**LA-1811**

**DT TRANSPORT or Prescott uFCPGA  
with ATI-RC300M+SB200 core logic**

**REV:1.0**

### *Version Change List ( P. I. R. List ) for Power Circuit*

AGPAND LVDS MUXED SIGNALS

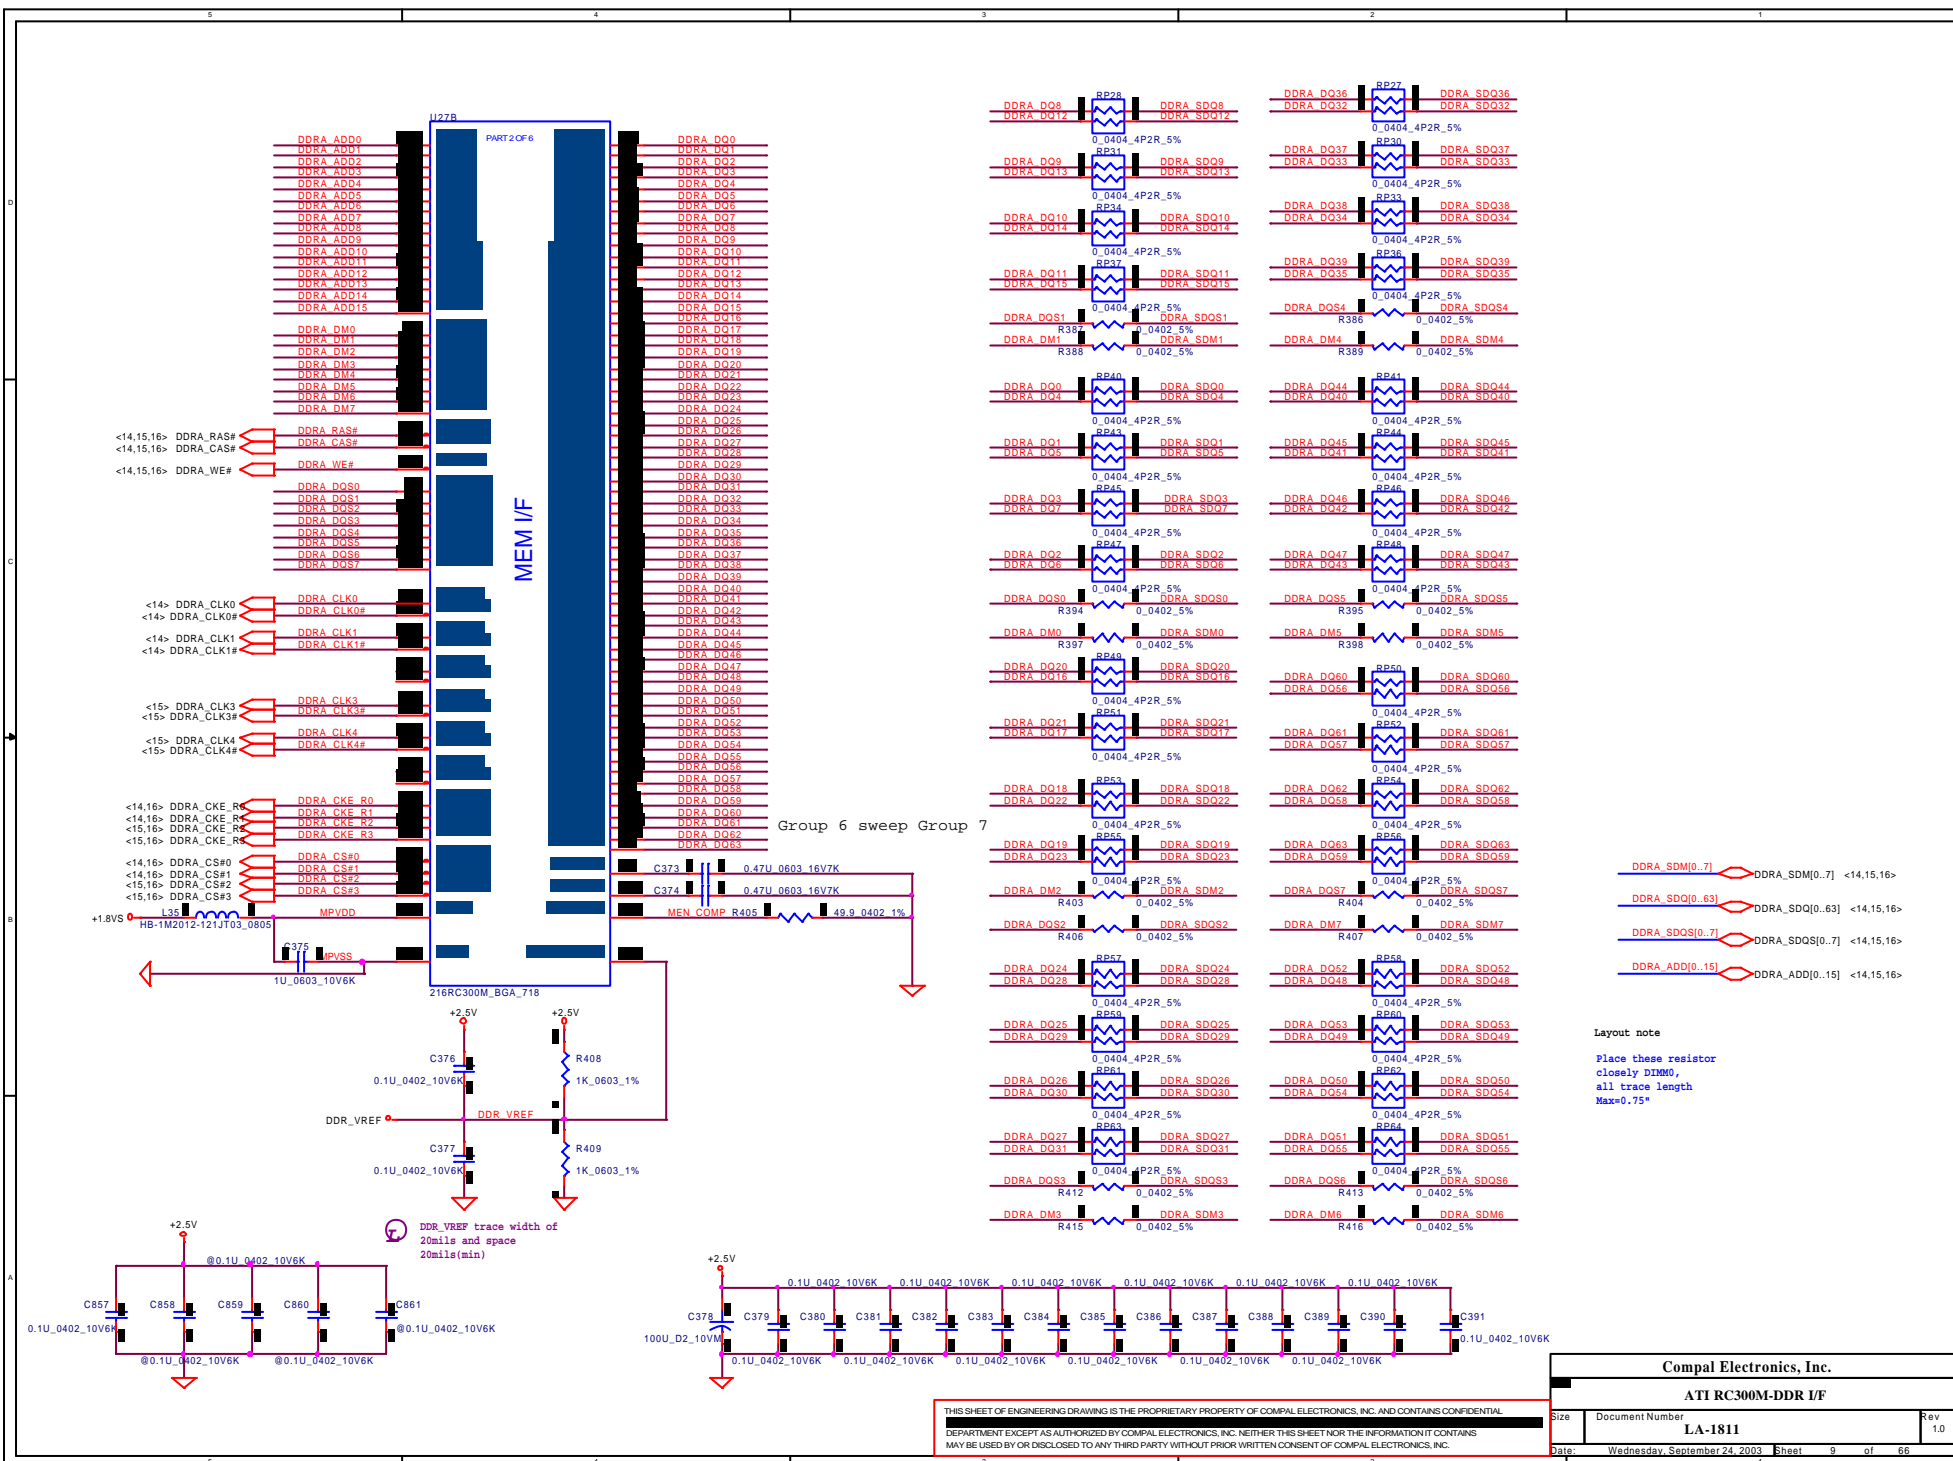
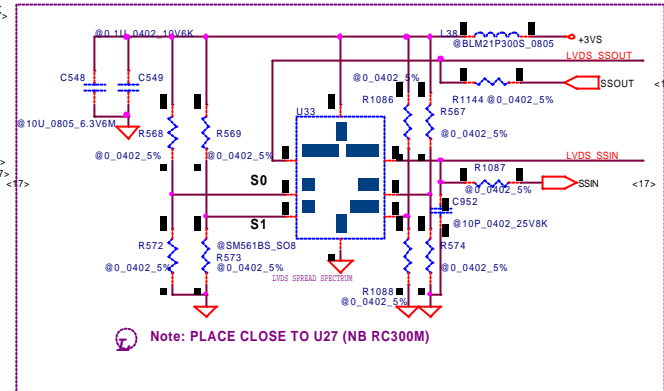
**7.Add De-coupling capacitor for AGP power pins on RC300M and VGA chip because of ATI request . <Page 10> 92.03.21.**

30. Change R994.1 - AGP\_DEVSEL# -> AGP\_SBA1(DDC\_DAT), R995.1 AGP\_IRDY# -> AGP\_SBA0(DDC\_CLK). <Page 10> 92.04.21.

-Add C937-C946,C862,C863,C865-C871(0.1U\_0402\_10V6K) . (Modify CKT,BOM&Layout)

| <b>LCD,CRT,TV-OUT &amp; Inverter BD CONN.</b> |                               |       |          |

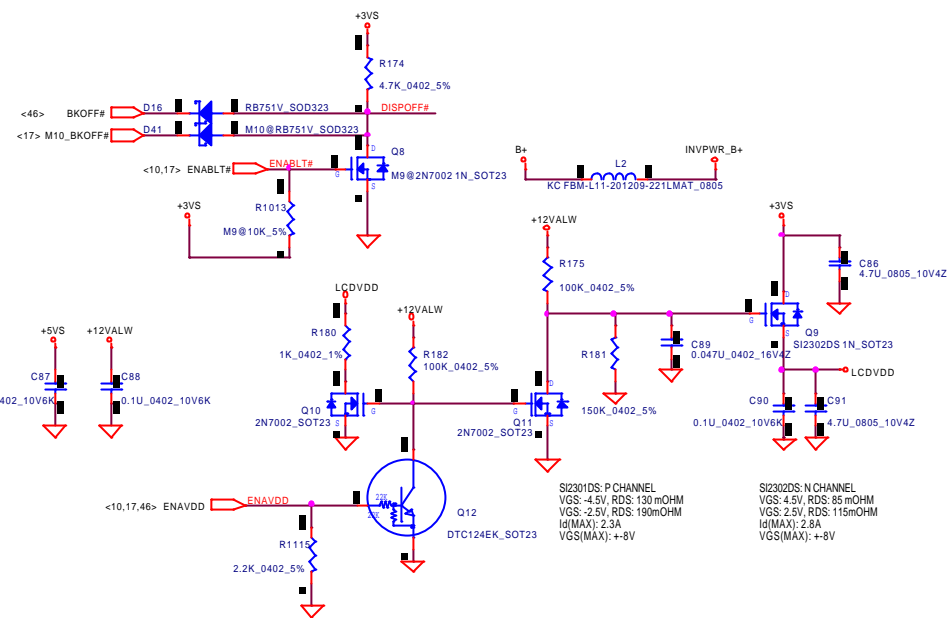
**4.Add 3VDDCDA & 3VDDCCL pull hing CRT\_VCC circuit. <Page 25> 92.04.09.**

| Item | Fixed Issue | Reason for change   | PAGE              | Modify List  | M.B. Ver. |
|------|-------------|---|-------------------|--|-----------|
| 9    |             | Solve power leakage from GRT                                | 25                | Change R619-1 and R622-1 net from +5VS to GRT_VCC  | 0.5       |

| Item | Fixed Issue | Reason for change  | PAGE  | Modify List   | M.B. Ver. |
|------|-------------|--|---|---|-----------|
| 23   |             | Solve Tr and Tf of H-sync/V-sync over Spec issue for high resolution CRT           | 25  | Delete Q68, Q64, R619, R620, R621 and R612; Add U57, U58 and R1150  | 0.5       |
| 28   |             | Decrease overshoot & undershoot  | 25  | Add R1153 and R1154   | 0.6       |

-Add Q13.1-R1117 to +CRT\_VCC & Q14.1-R1118 to CRT\_VCC. (Modify EE Circuit)

File  
Parallel port and FDD

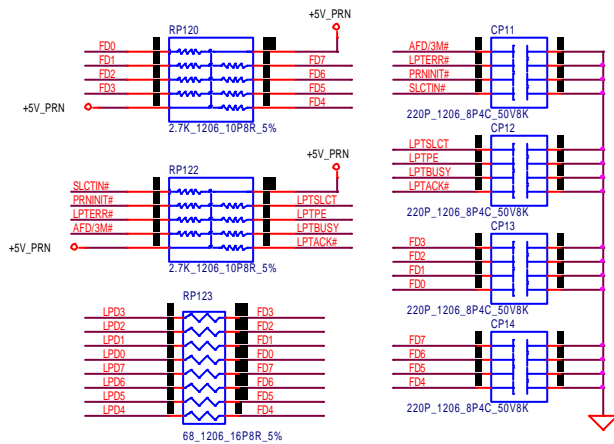
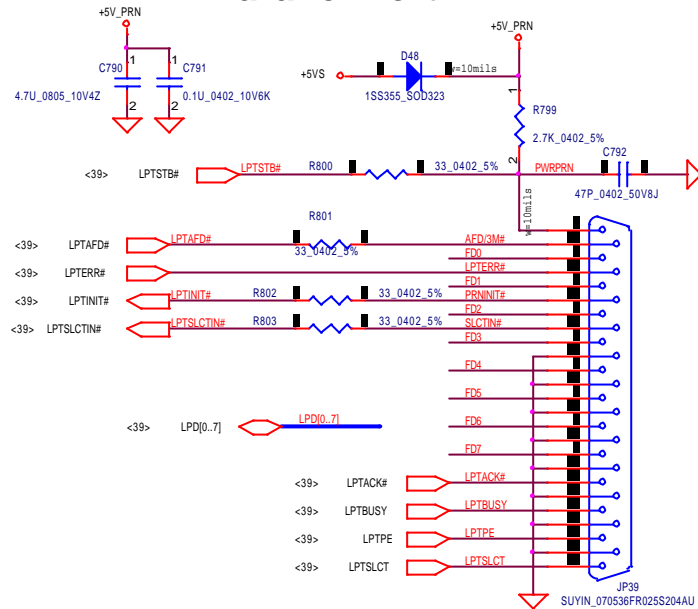
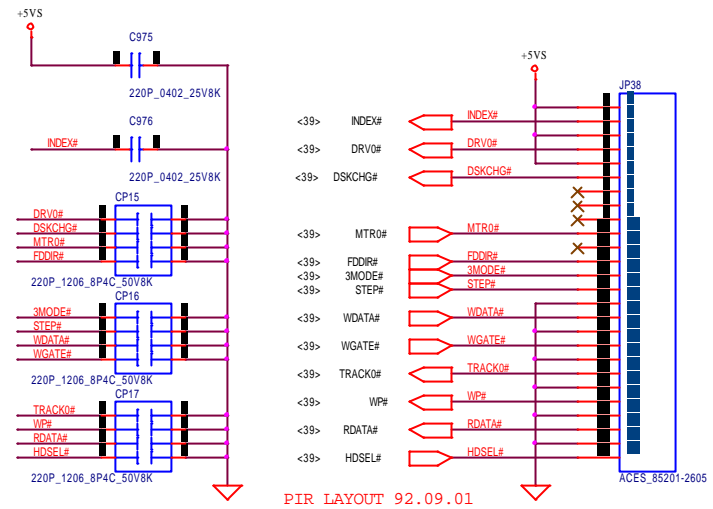
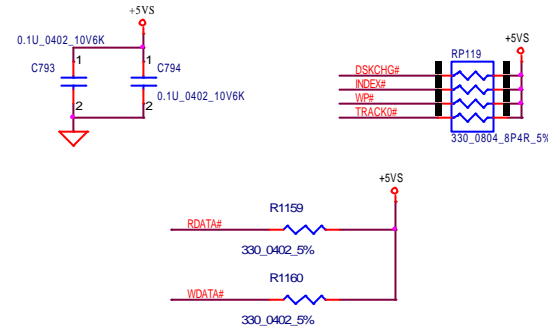
| Item | Fixed Issue | Reason for change  | PAGE  | Modify List   | M.B. Ver. |
|------|-------------|--|---|---|-----------|
| 31   |             | The pin-definition of FDD conn. was error on rev0.5 M/B                            | 40  | Correct the pin-definition for JP38   | 0.6       |
| 32   |             | VIA recommendation   | 40  | Change RP119 from 1K to 330; Delete RP121; Add R7 and R?  | 0.6       |

DC/DC Circuits

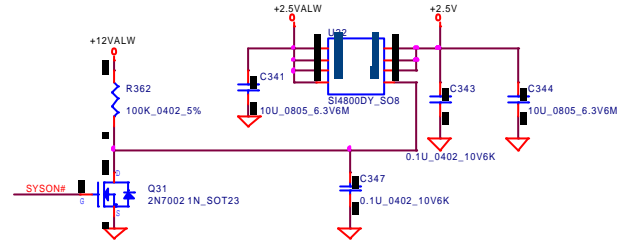
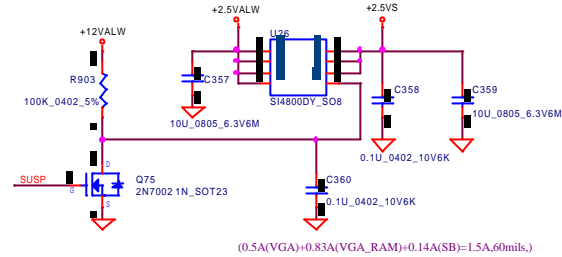
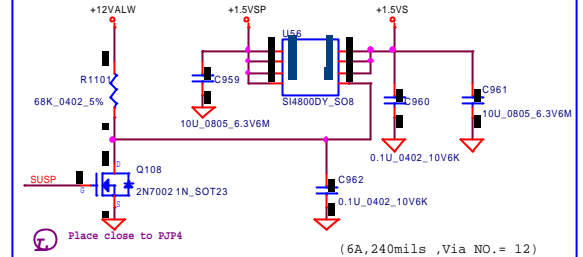
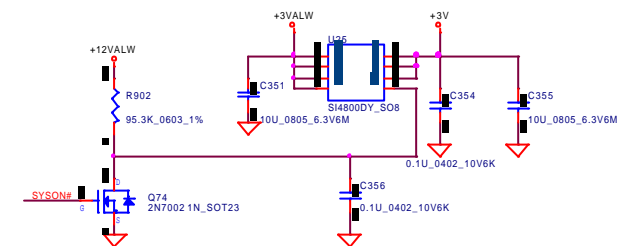
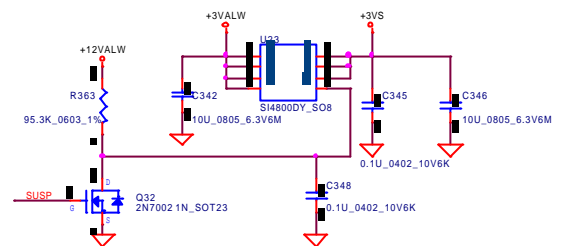
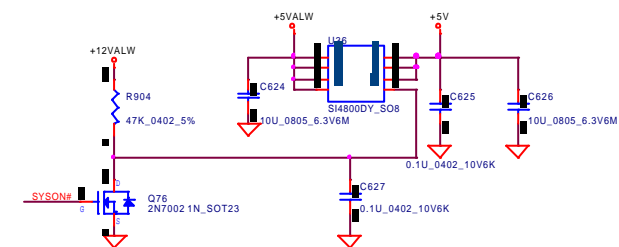
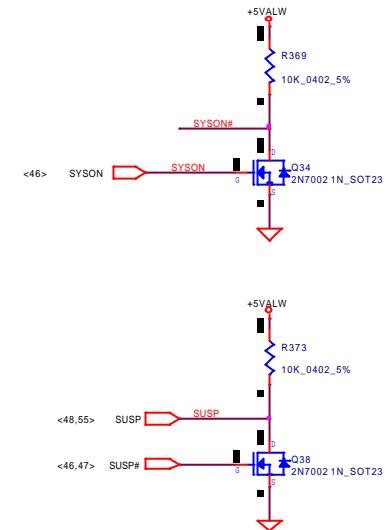
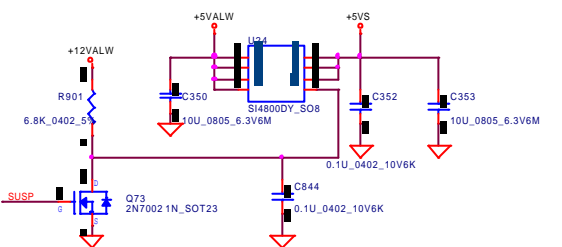
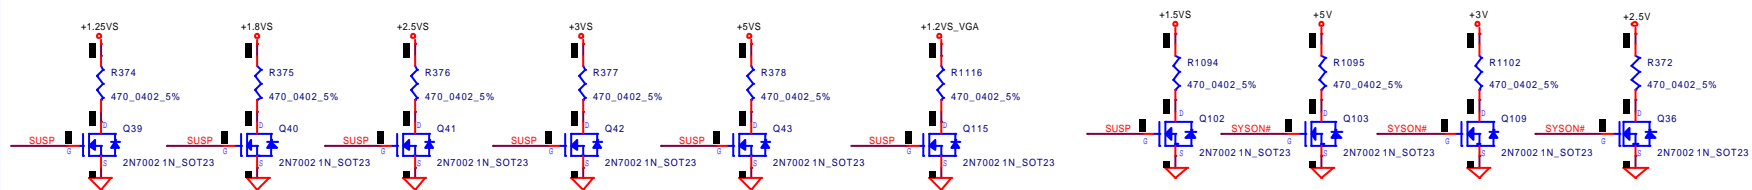
**9. Add the power source +5V and +1.5VS discharge circuit for ATI request . <Page 49> 92.03.23.**

**17.Add a power transfer circuit to fix +1.5VS leakage issue . <Page 49> 92.03.25.**

**20. Add the power source +3VS discharge circuit by Brian . <Page 49> 92.03.26.**

**23. Add the power source +3V discharge circuit for ATI request . <Page 49> 92.03.27.**

**3.Add +1.2VS\_VGA Discharge Circuit. <Page 49> 92.04.09.**

| Item | Fixed Issue | Reason for change   | PAGE              | Modify List  | M.B. Ver. |
|------|-------------|---|-------------------|--|-----------|
| 15   |             | Solve M10 can't power up issue                              | 49                | Change R1101 from 100K to 56K; Change R901 from 91K to 27K   | 0.5       |
| 16   |             | Add discharge components                                    | 49                | Add R372, R1095, R1102, Q36, Q103 and Q109   | 0.5       |

| Item | Fixed Issue | Reason for change  | PAGE  | Modify List   | M.B. Ver. |
|------|-------------|--|---|---|-----------|
| 41   |             | Modify +5V power-up timing to lead +3V   | 49  | Change R904 from 91K to 47K   |           |

-Add R1094,R1095(470\_0402\_5%),Q102,Q103(2N7002 1N\_SOT23) . (Modify CKT,BOM&Layout)

-Add U56(SI4800DY\_SO8),Q108(2N7002 1N\_SOT23),R1101(100K\_0402\_5%),C960(0.1U\_0402\_10V6K),  
C961(10U\_1206\_6.3V6M),C962(3900P\_0402\_50V7K) . (Modify CKT,BOM&Layout)

-Change Q42 from @2N7002 1N\_SOT23 to 2N7002 1N\_SOT23 . (Modify CKT&BOM)

-Add R1102(470\_0402\_5%),Q109(2N7002 1N\_SOT23) . (Modify CKT,BOM&Layout)

-Add +1.2VS\_VGA Discharge Circuit(R1116 , Q115 to SUSP). (Modify EE Circuit)
